H10147

DESCRIPTIVE REPORT

Type of Survey ..... Hydrographic  
Field No. .... WH-05-01-84  
Registry No. .... H-10147

State ..... Wisconsin  
General Locality ..... Lake Superior  
Sublocality ..... Ashland Harbor

JD 243-244

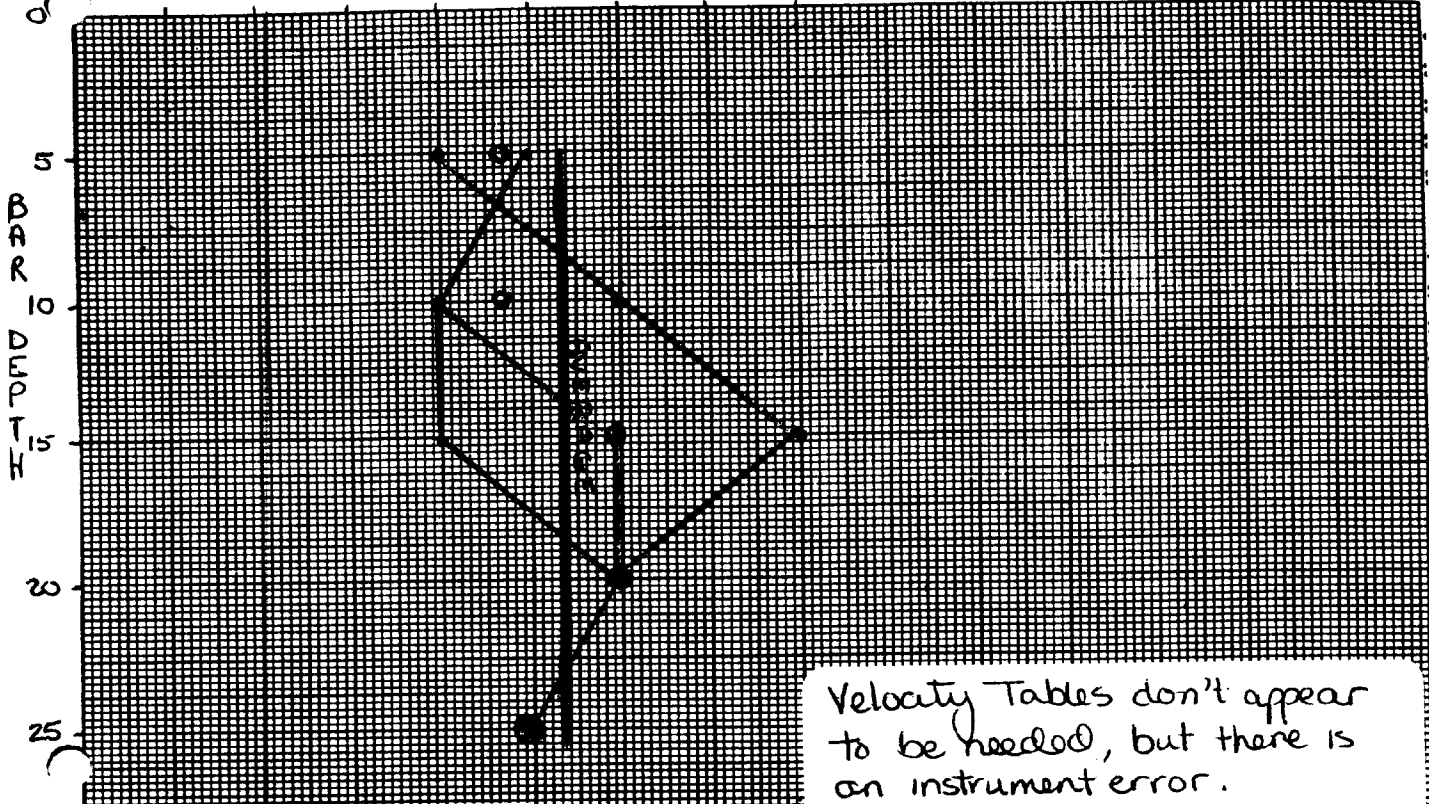
Velocity Tables don't appear to be needed, but there is an instrument error.

JD 214-215

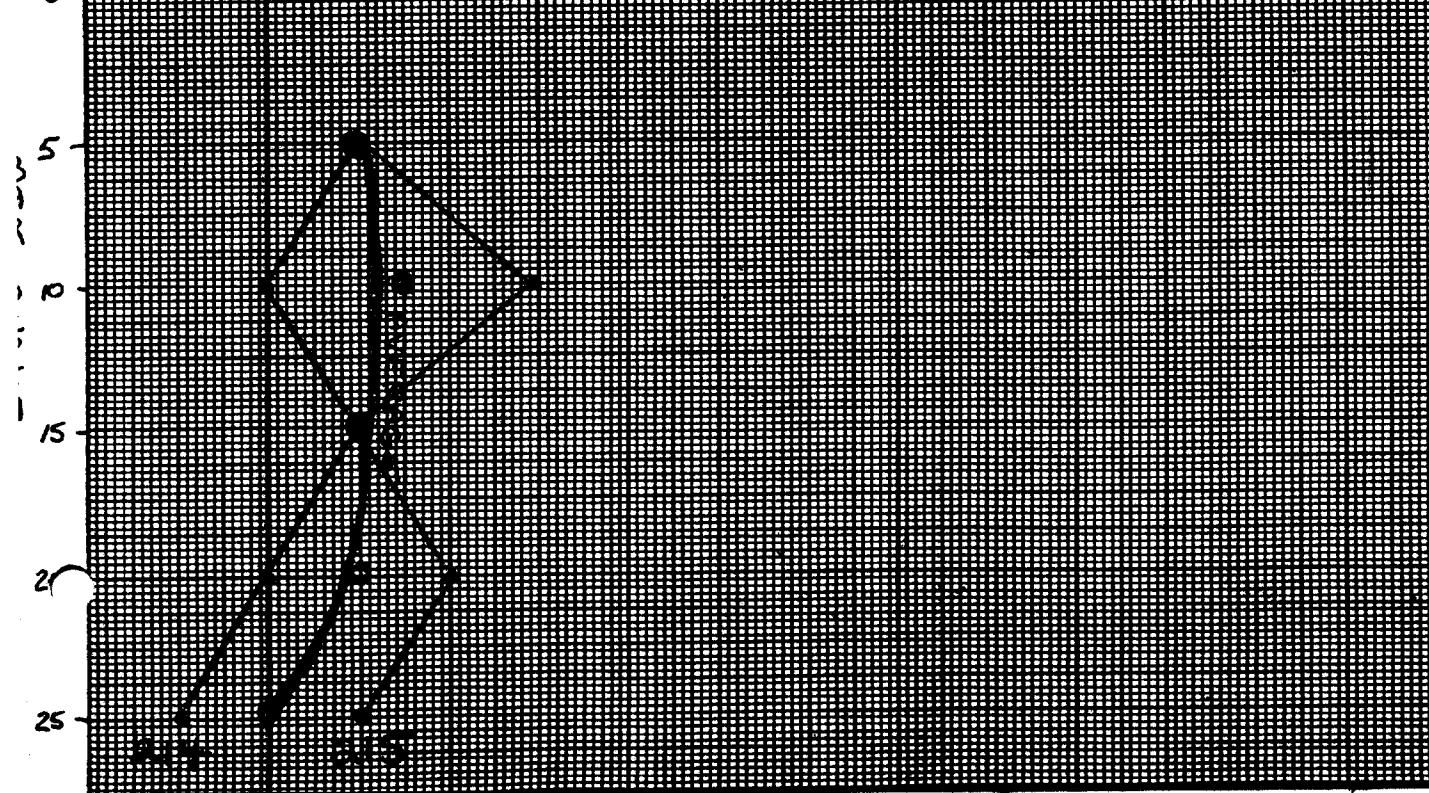
Instrument error?  
gain or calibration

JD 248-252  
VELOCITY + INSTRUMENT ERROR

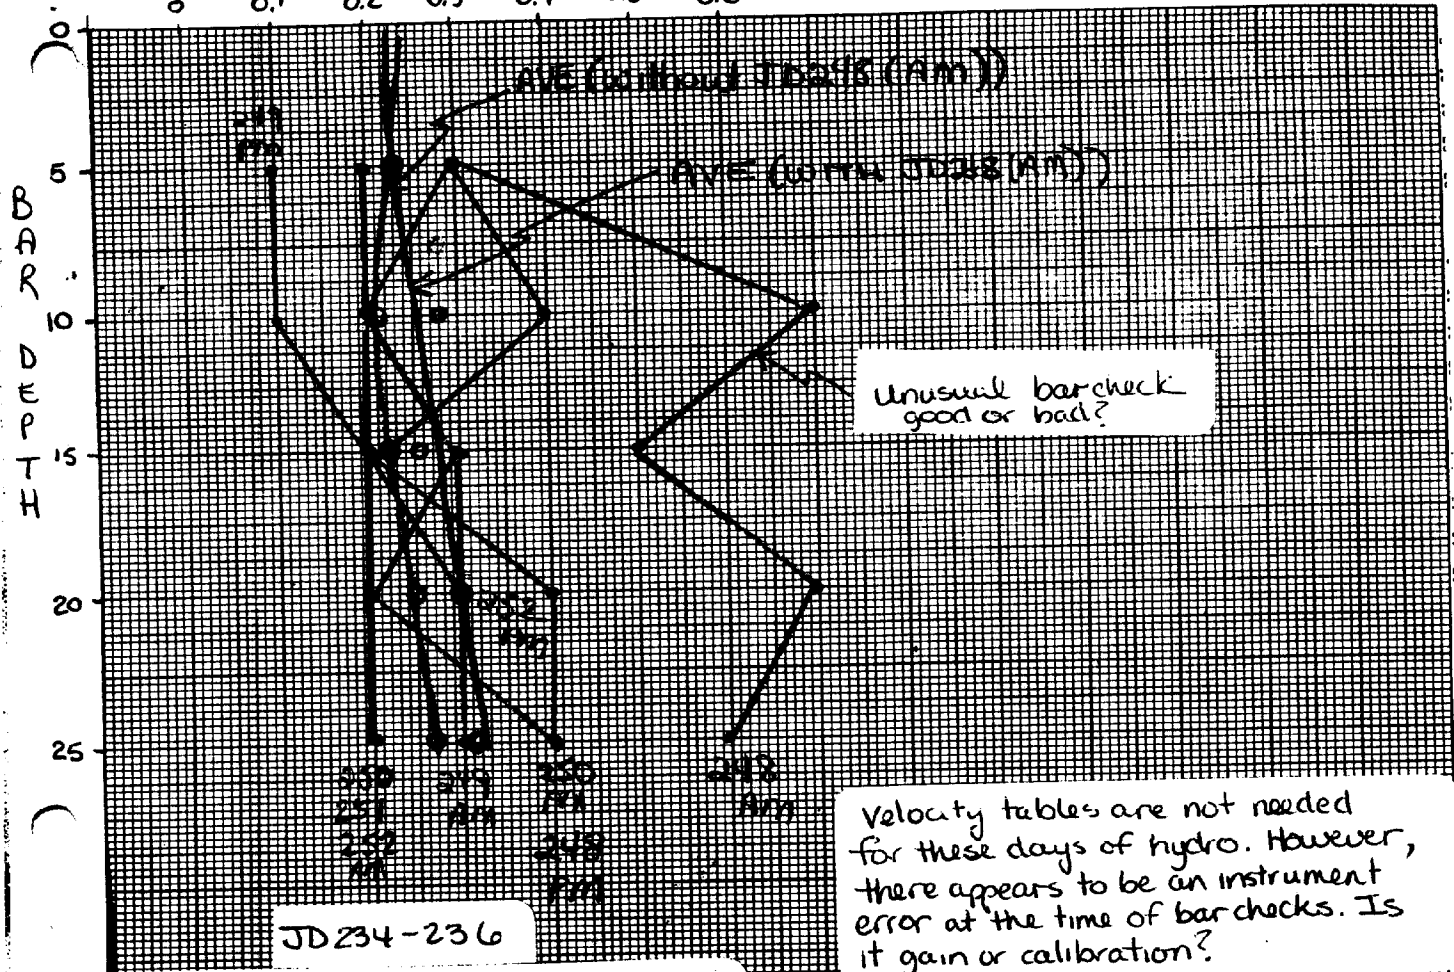
Velocity tables are not needed for these days of hydro. However, there appears to be an instrument error at the time of bar checks. Is it gain or calibration?
